METROPOLITAN GOVERNMENT OF NASHVILLE AND DAVIDSON COUNTY

STAFF RECOMMENDATION
1400 and 1402 Ordway Place
February 15, 2017

Application: New construction—infill and DADU; Setback determination
District: Lockeland Springs-East End Neighborhood Conservation Zoning Overlay
Council District: 06
Map and Parcel Number: 08309029500
Applicant: Randy Rayburn & Sonata Stanton
Project Lead: Melissa Baldock, melissa.baldock@nashville.gov

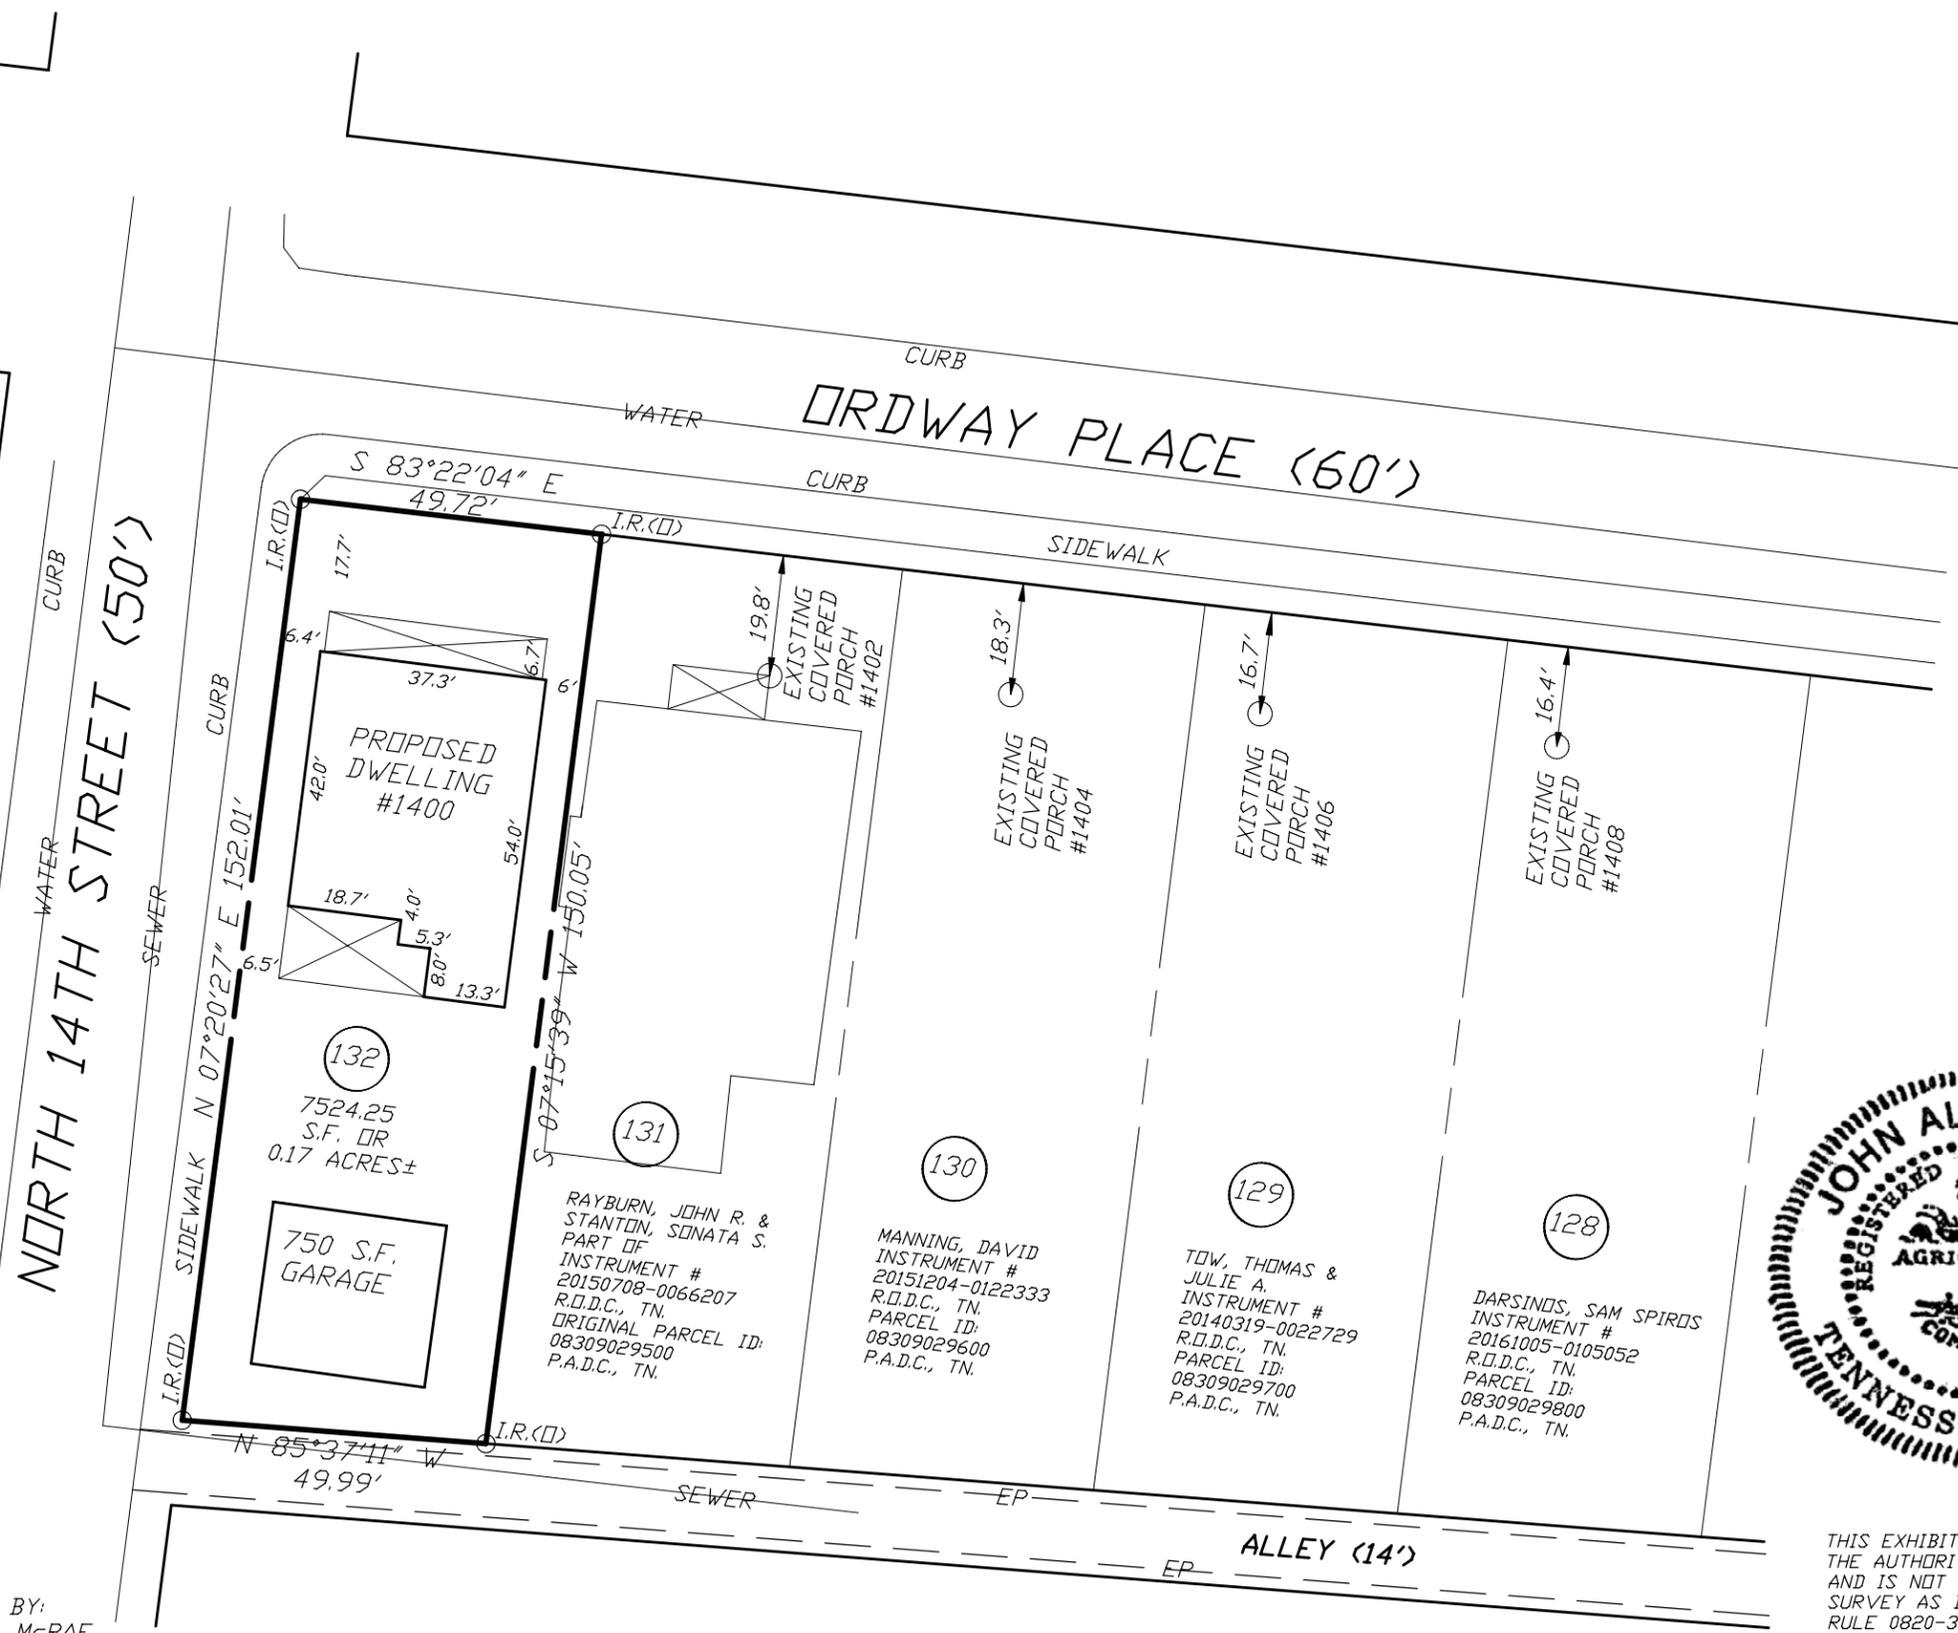
1402 Ordway (Existing Building) Setback: The existing house at 1402 Ordway Place will not meet the base zoning five foot (5') side setback on the right side. The bulk of the house will be situated approximately two feet, six inches (2'6") from the new right side property line (Figure 2). However, a one-story side bay will sit less than one foot (1') from the side property line (Figure 3).

Figure 2 (left) is the proposed new site plan showing that 1402 Ordway is proposed to be less than five feet (5') from the side property line. Figure 3 shows the bay that will sit less than a foot (1') from the side property line.

The applicant is proposing to situate the house approximately six feet, six inches (6'6") from the 14th Street side property line. Base zoning requires that houses on corner lots like this one be a minimum of ten feet (10') from the side street property line. The infill therefore requires a side setback determination. Typically, the Commission has required applicants to meet the ten foot (10') side setback on corner lots, although there have been a handful of cases where the Commission has reduced the side setback when that met the historic context.

Staff finds that a side setback change could be appropriate here because the house needs to sit a minimum of six feet (6') from the interior-side property line in order to meet fire code for the distance between two houses, whereas base zoning would typically allow only a five foot (5') setback. In addition, there are neighboring historic houses that have side setbacks less than ten feet (10') from their 14th Street property lines. For instance, the house across the street at 1401 Ordway has a side porch that is approximately eight feet (8') from the side property line, although the bulk of the house does meet the ten foot (10') side setback (Figure 4). 1401 Gartland, which is across the alley behind 1400

With the condition that the front wall of the infill be pushed back to line up with the front wall of the historic house, staff finds that the proposed setbacks meet Section II.B.3. of the design guidelines.

revisions
drawn by D.O.
project number
date January 31, 2017
scale 1/8" = 1'-0"
sheet title Elevations
sheet A2.1

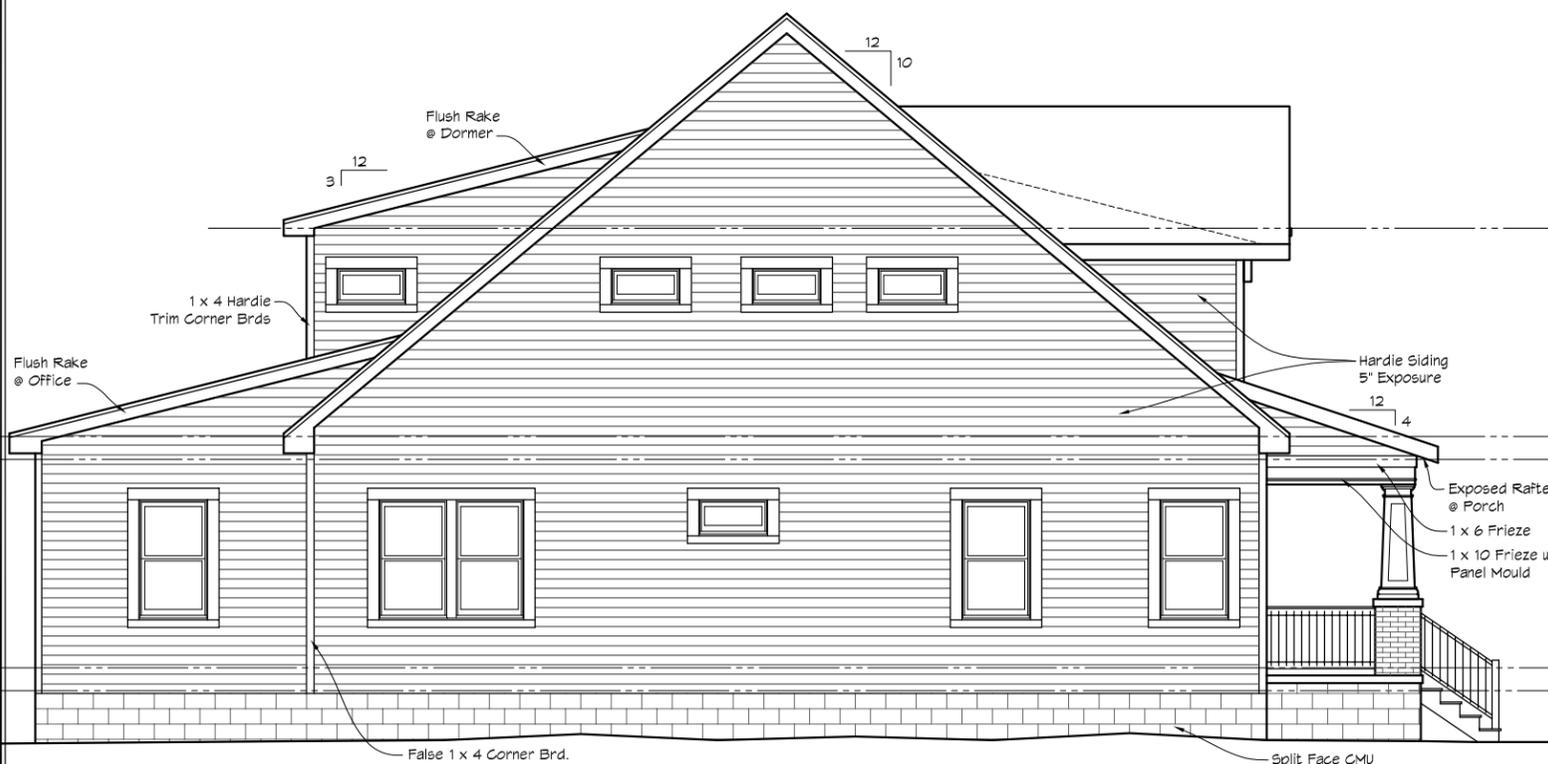
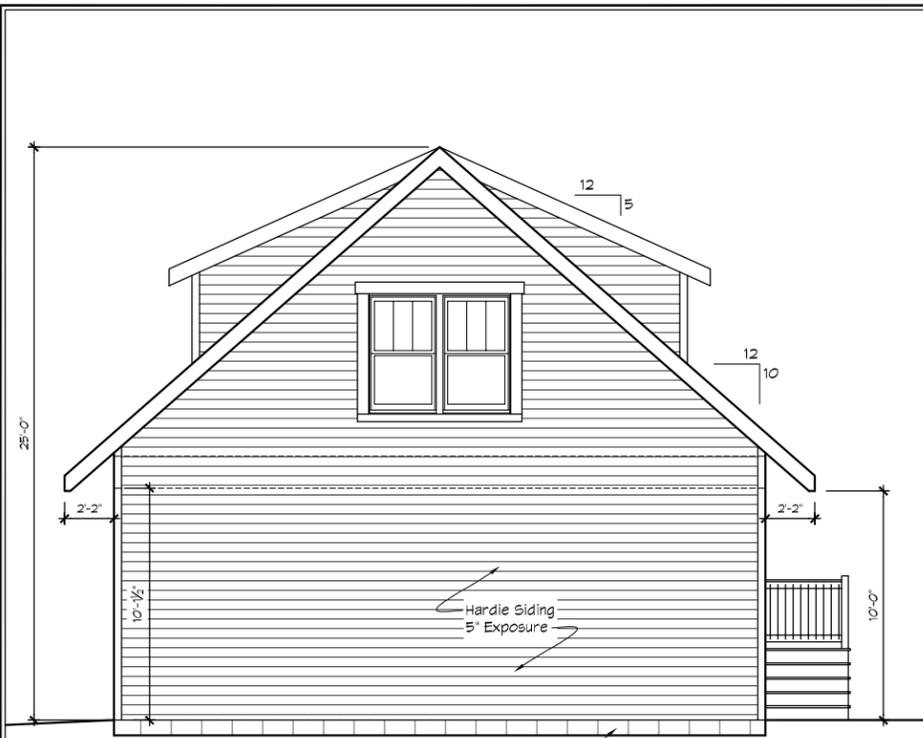
Infill Height & Scale: The proposed infill has a one-and-a-half story form, which is appropriate since the houses in the immediate vicinity are largely one-and-a-half stories. The proposed height is approximately thirty-one feet, nine inches (31'9") tall from grade. By comparison, the house next door is approximately thirty feet (30') tall from grade, and neighboring houses are between twenty-six and twenty-eight feet (26'-28') tall from grade. Staff recommends that the height be reduced so that it is no more than thirty feet (30') tall from grade.

Infill Roof form: The infill's primary roof form is a side gable with a 10/12 slope. The front porch will have a shed roof with a 4/12 pitch, and the rear porch will have a shed roof with a 3/12 pitch. The front dormer is two gabled dormers connected by a shed dormer, which is sometimes referred to as a Nantucket dormer. Staff finds that the dormer's width of thirty feet (30') is too out of scale for the infill and the historic context and recommends that it be reduced in width by several feet. The front dormer is only inset one foot (1') from the wall below. The design guidelines state that front dormers should be inset a minimum of two feet (2') from the wall below, as historically, front dormers were modest in size and were setback two or more feet from the wall below. The Commission has been consistent in requiring that front dormers be inset two feet (2') from the wall below, and staff recommends that this front dormer follow that guideline.

Infill Proportion and Rhythm of Openings: There are no large expanses of wall space without a window or door opening, which meets the design guidelines. However, there are several window openings on the front and side facades that do not meet the historic proportion of window openings. Historically, most window openings were vertically-oriented, and the Commission has therefore discouraged horizontal window openings on front and side facades.

On the front façade, staff recommends that the applicant work with staff to enlarge the two square windows in the shed portion of the front dormer. On the left and right facades, staff recommends that the applicant use vertically oriented windows of a least four square feet (4 sq. ft.) in lieu of the horizontal windows. The use of some square windows may be appropriate, depending upon the location and visibility. With the condition that the applicant work with staff on the proportions of the square window openings on the middle section of the front dormer and on replacing the horizontal window openings on the side facades with square or vertically-oriented windows, staff finds that the infill's proportion and rhythm of openings meet Section II.B.7. of the design guidelines.

1. The infill's front wall line up with the front wall of the house at 1402 Ordway;
2. The infill's overall height be reduced so that it is no more than thirty feet (30') tall from grade;

4. The infill's front dormer be reduced in width and be inset two feet (2') from the wall below;
5. The applicant work with staff on the proportions of the square window openings on the middle section of the infill's front dormer and on replacing the horizontal window openings on the side facades with square or vertically-oriented windows;

revisions
drawn by D.O
project number
date January 31, 2017
scale 1/8" = 1'-0"
sheet title Garage Plans

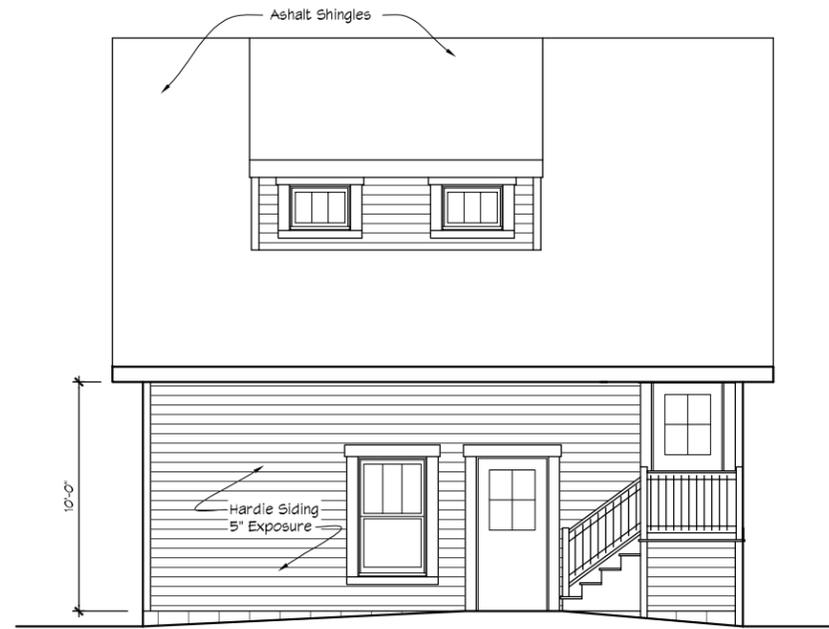
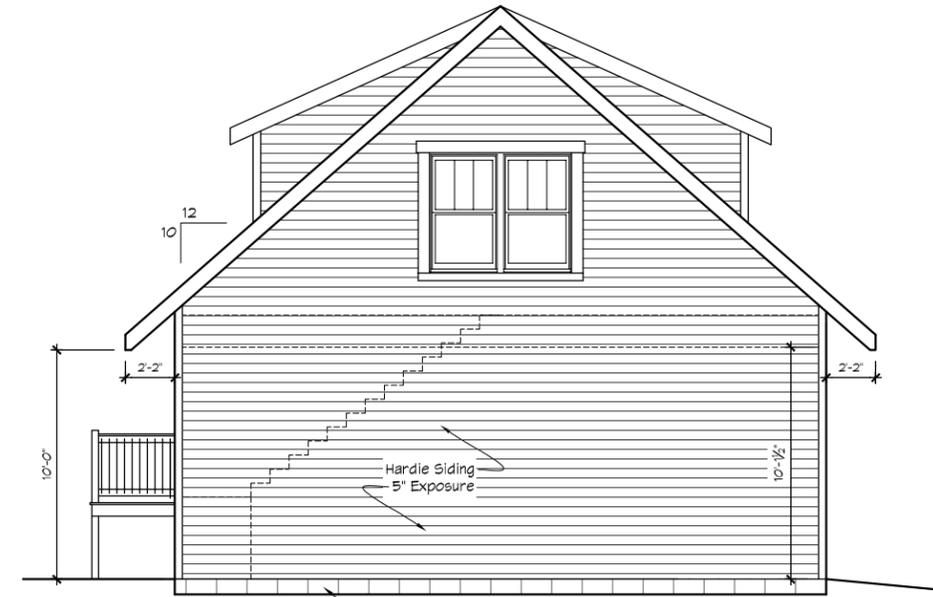
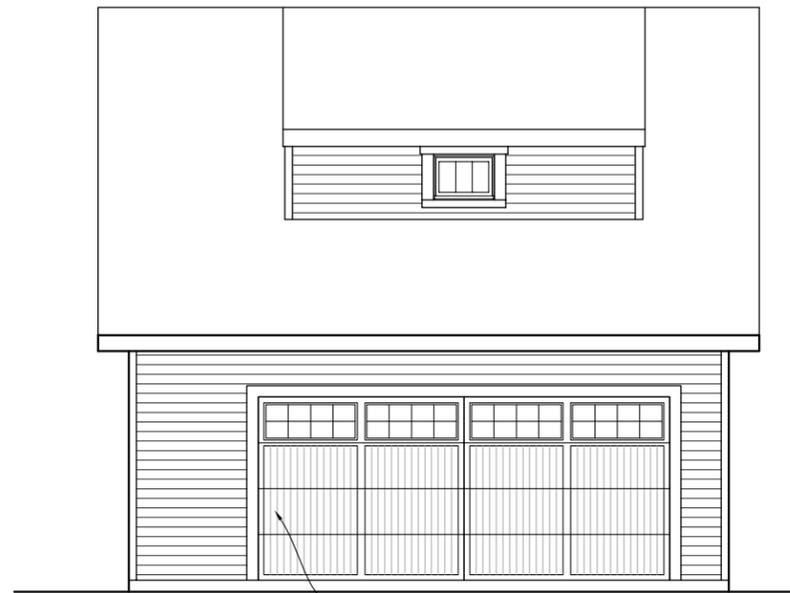
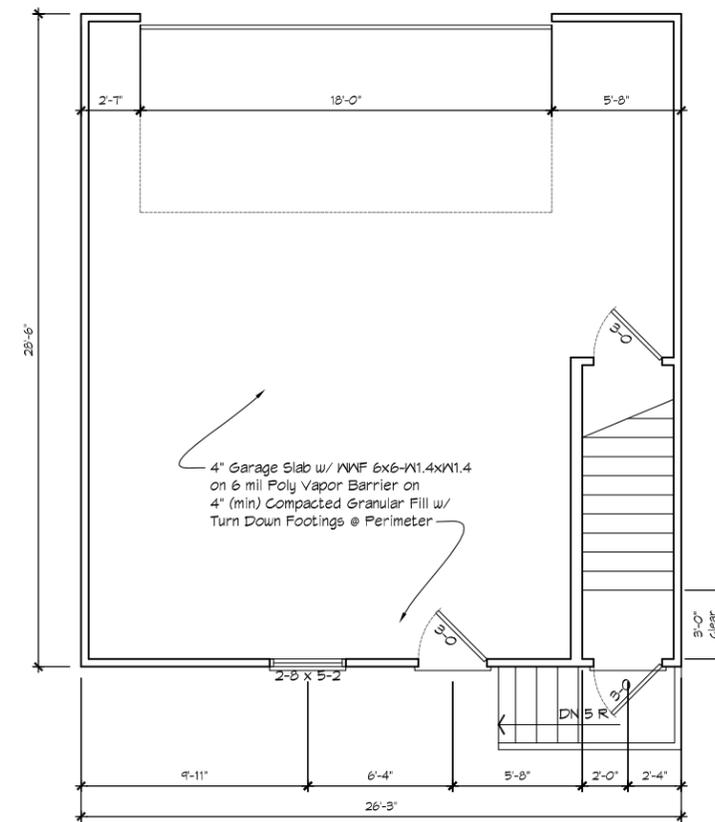
*The design guidelines limit the height of DADUs to twenty-five feet (25'). Staff recommends that the height of the DADU be reduced by nine inches (9") to meet the design guidelines.

With the condition that the DADU be reduced to be no taller than twenty-five feet (25') from grade, staff finds that the DADU meets Section II.B.8 of the design guidelines and 17.16.30.G. 7 of the ordinance.
